## Dear Distributors,

- TurfBoy TB1
- BeltSpreader BS800

have received a drag brush upgrade which will be implemented immediately. The drag brush will no longer be foldable, but rigid as the one who comes with the TurfBoy TB2.

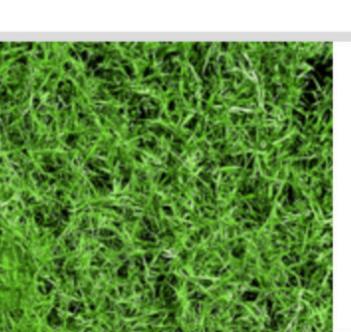
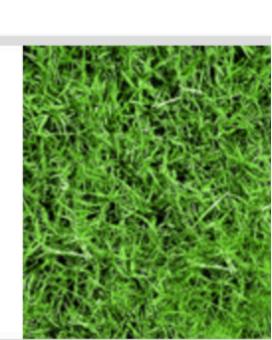
Advantages of the rigid brush in comparison to the folding brush:

- No bouncing while driving
- Reduced risk of a collision on poles / edges
- Reduced production costs
- Reusability of equal parts (TurfBoy and BeltSpreader)
